Updated: November 2, 2021

RE: RE-ZONING AND DEVELOPMENT PERMIT APPLICATION: 1042-1044 RICHARDSON STREET

PLANNING STAFF REVIEW: APRIL 18, 2021

6 Solar Study - Summer Solstice noon
1 : 500

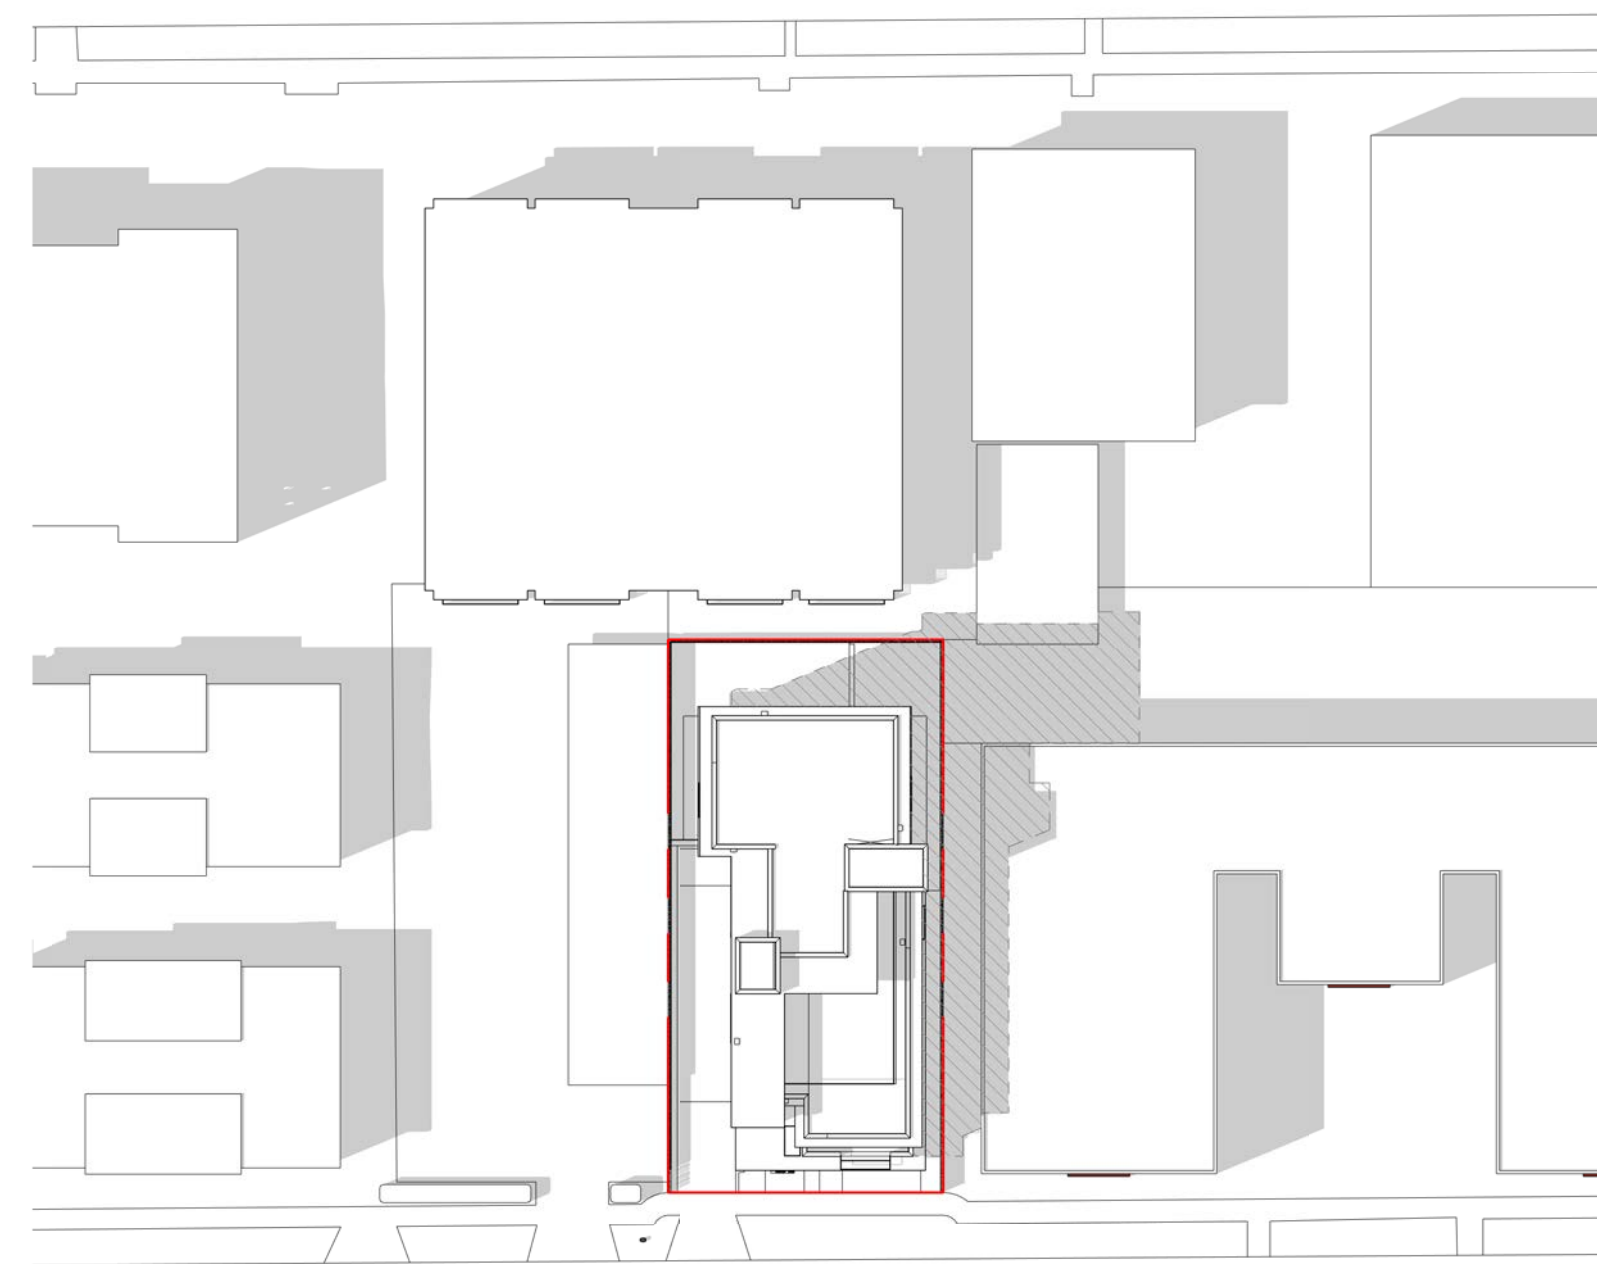
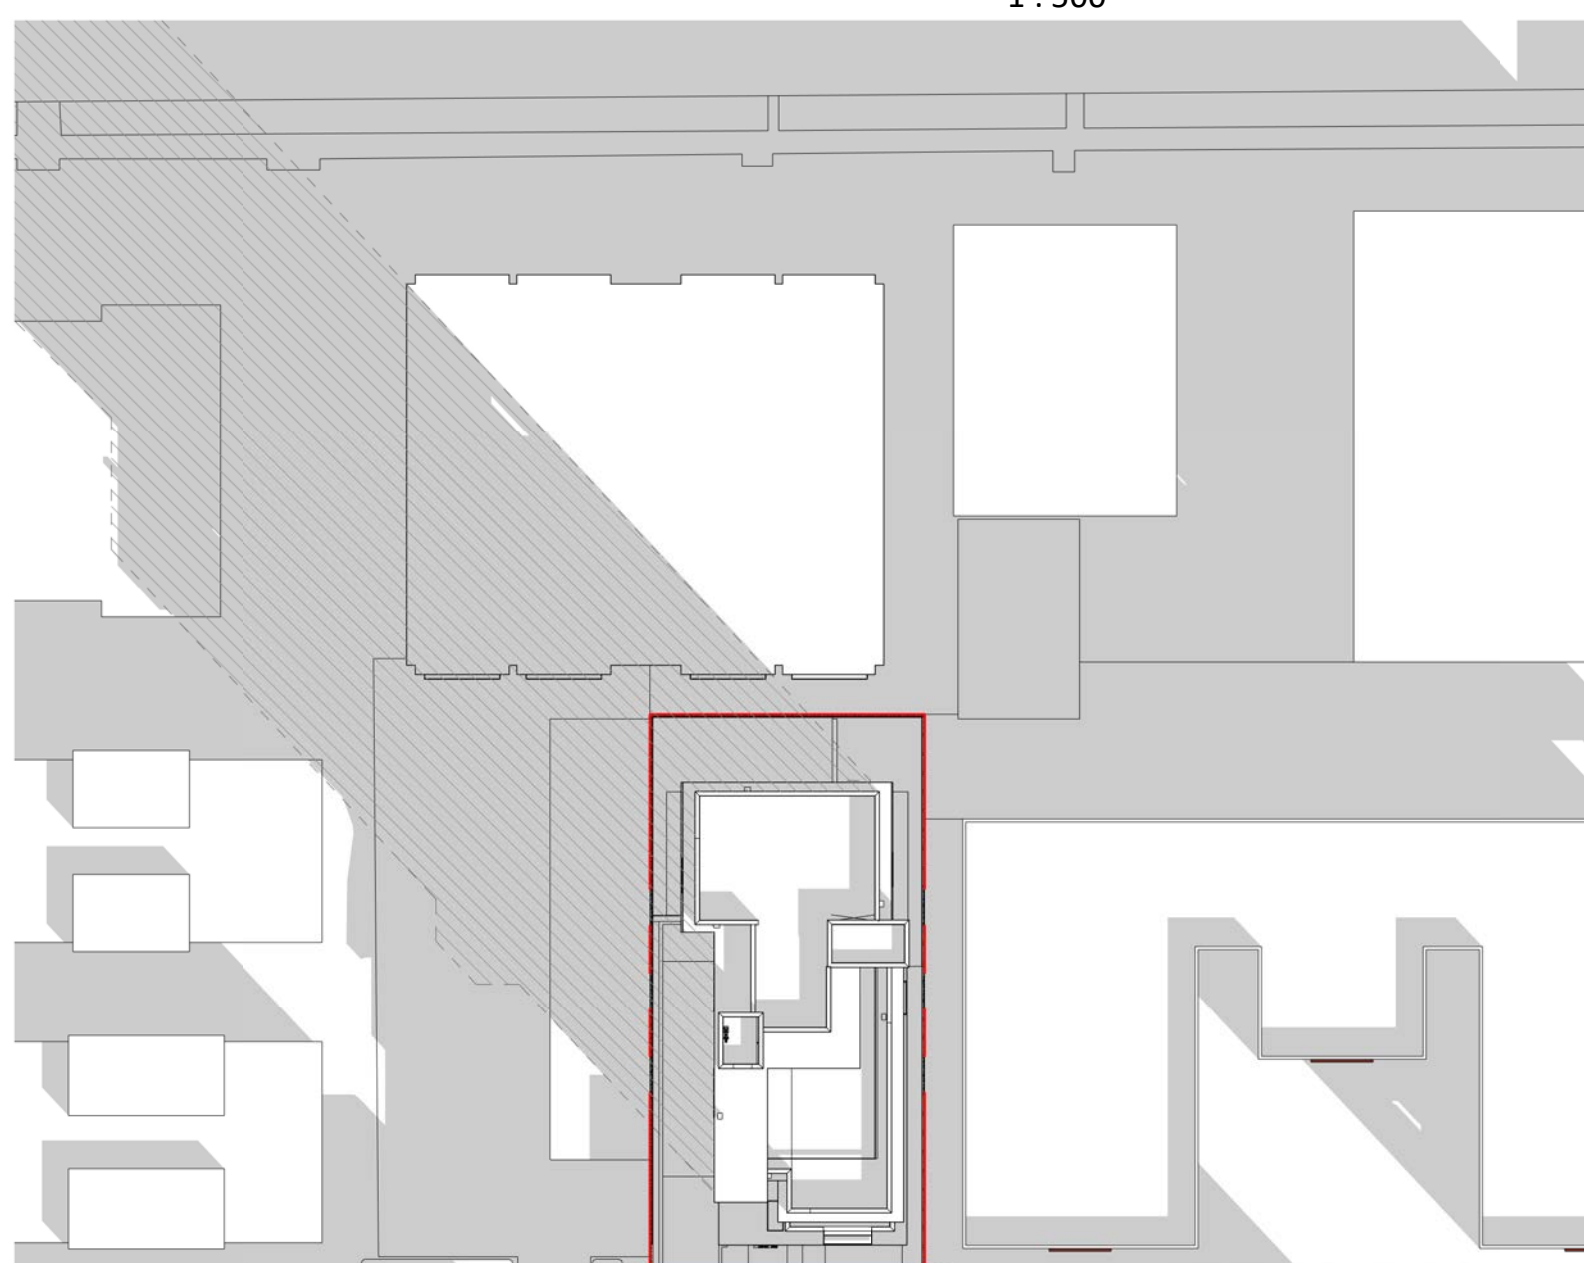
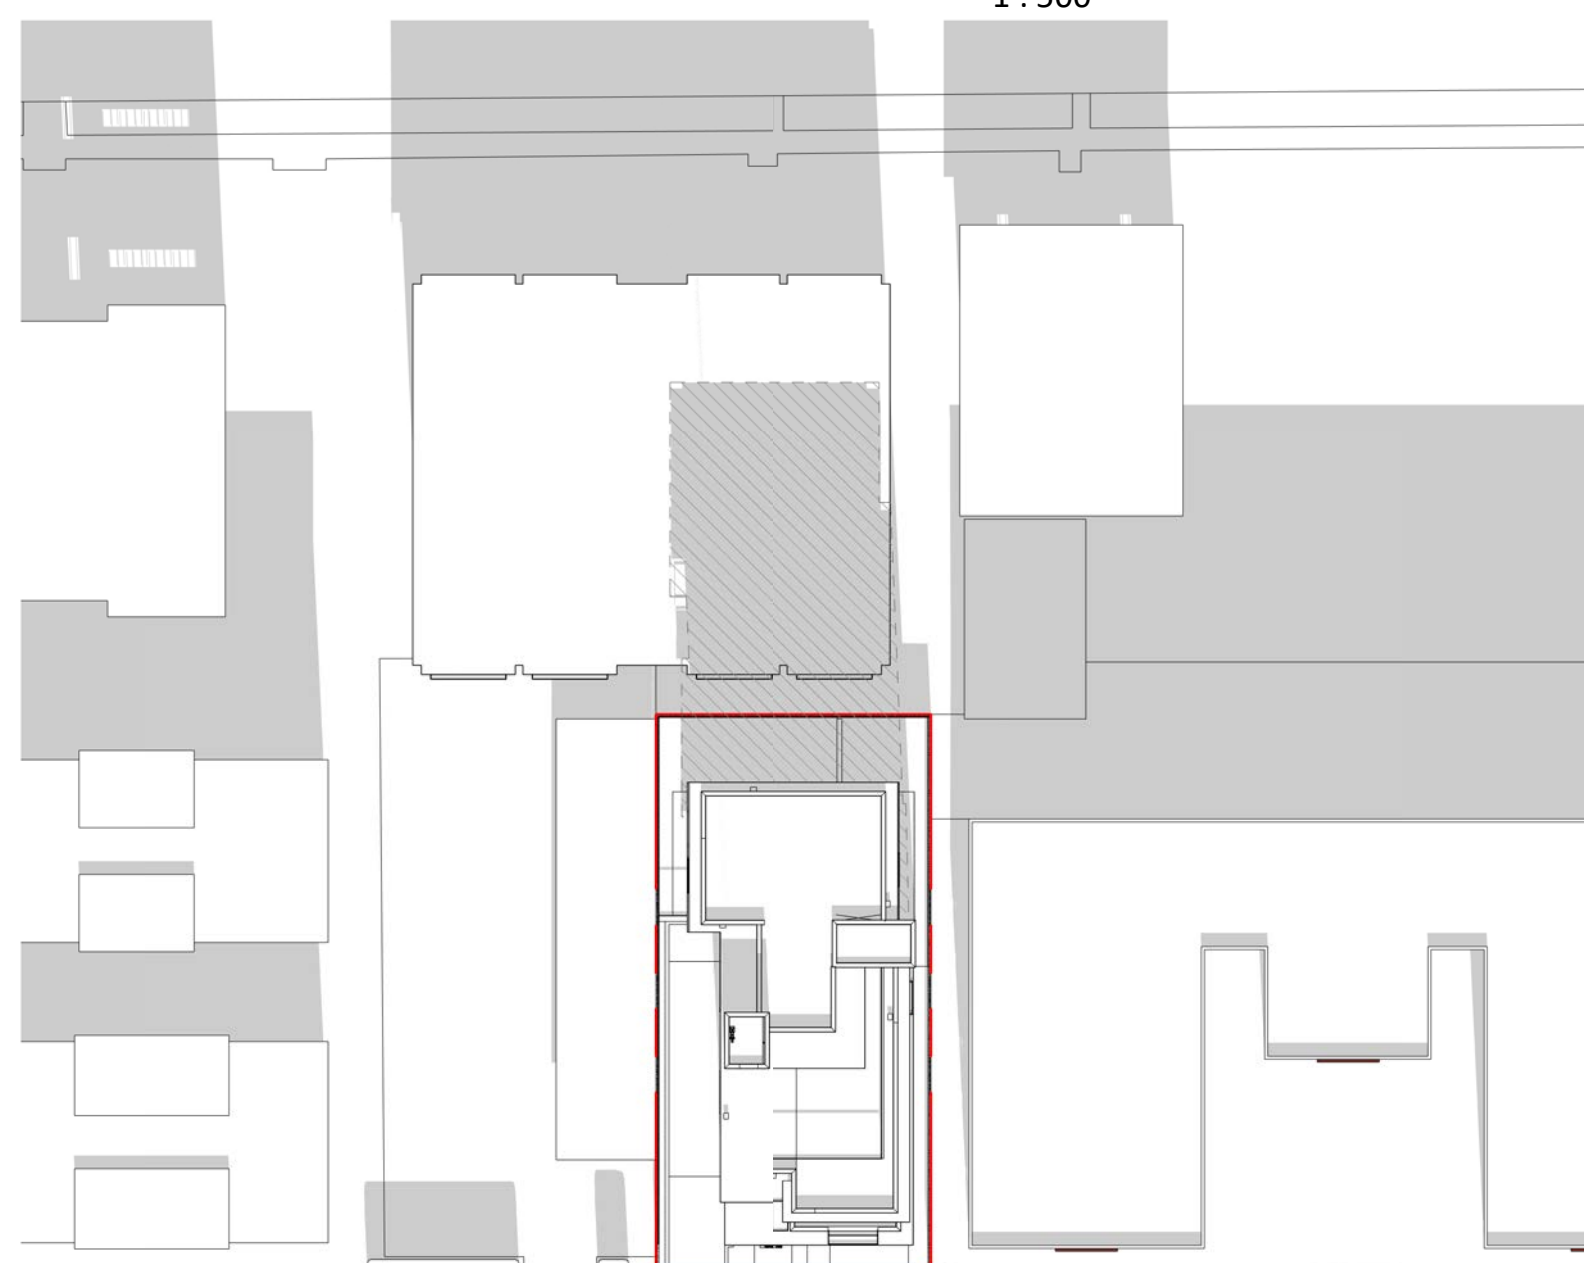
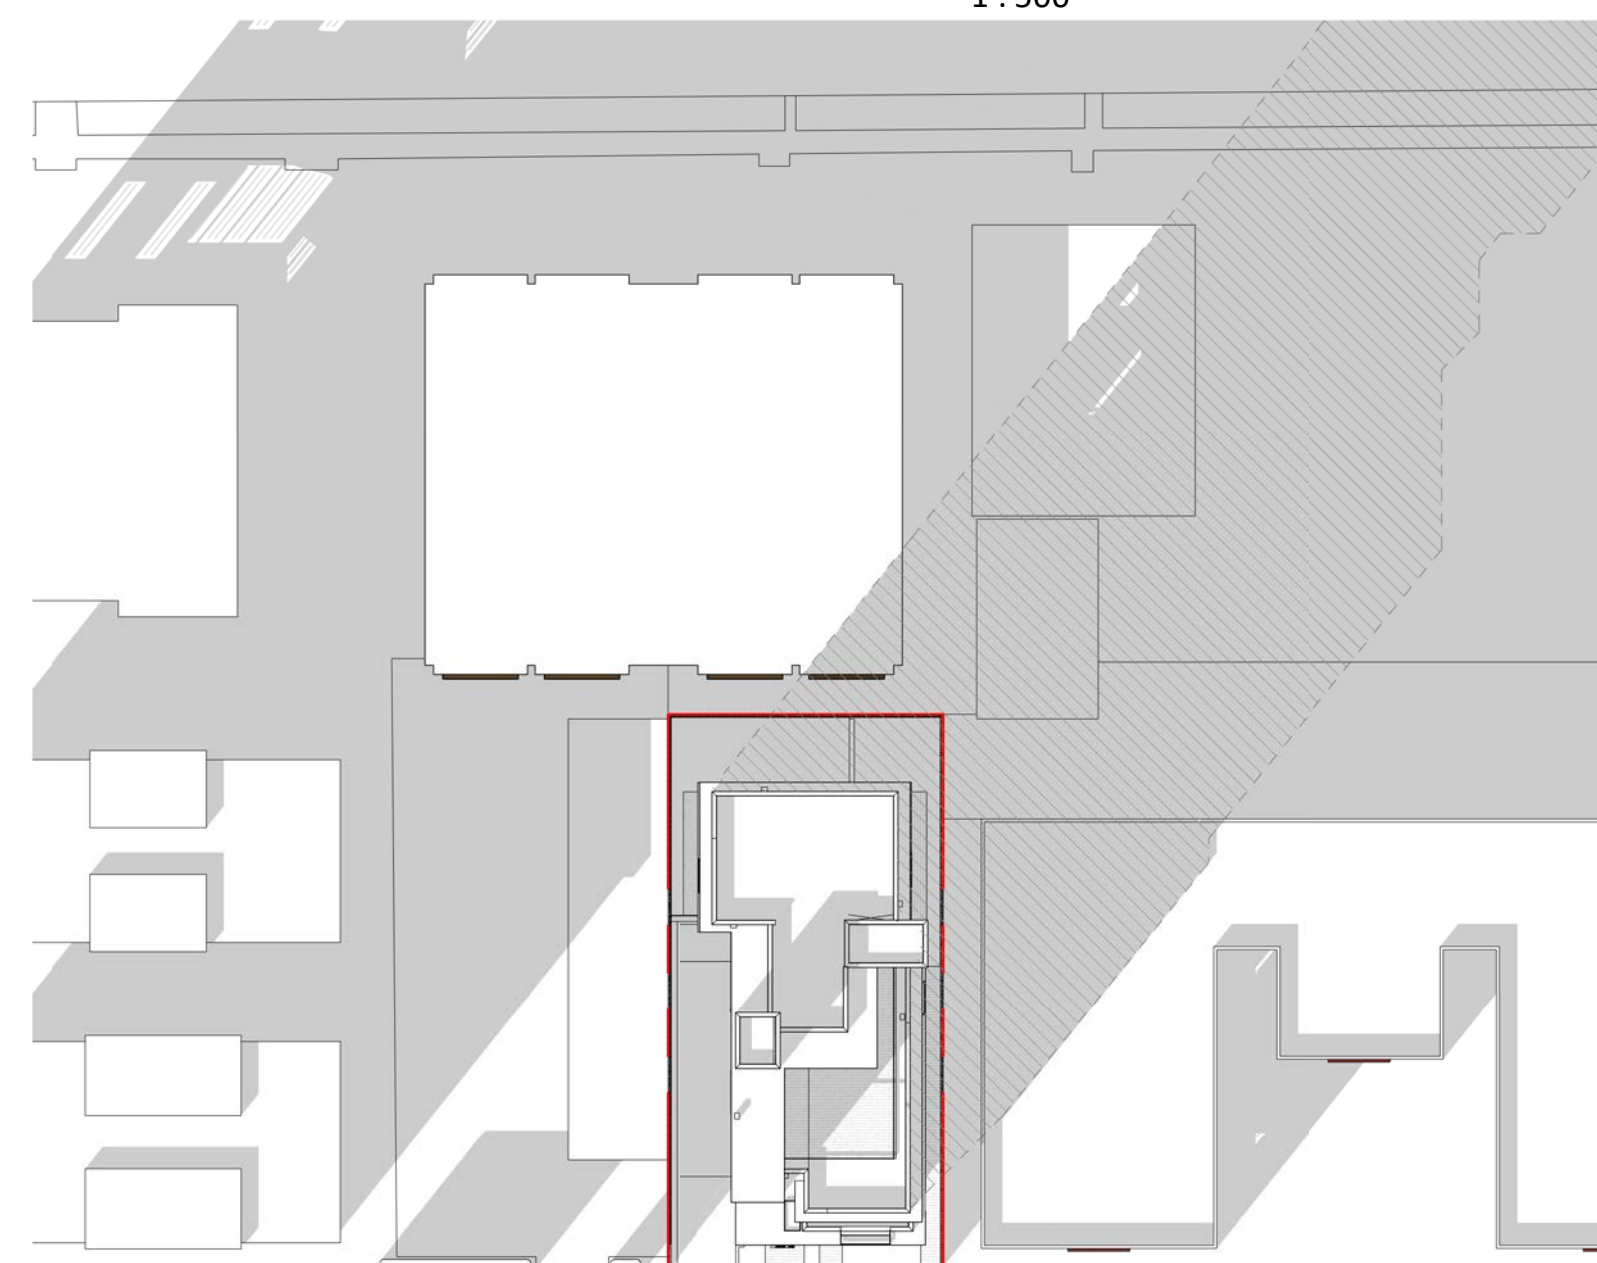
Condition #4: *Please provide a 3D shadow analysis to help assess the shadowing impacts of the proposed building.*

Applicant Response / Actions Taken: A 3D shadow analysis has been completed and is included in the revised plan set. Placing the roof deck centered on the rooftop, and away from the northern property line, reduces shadowing impacts on neighbouring properties.
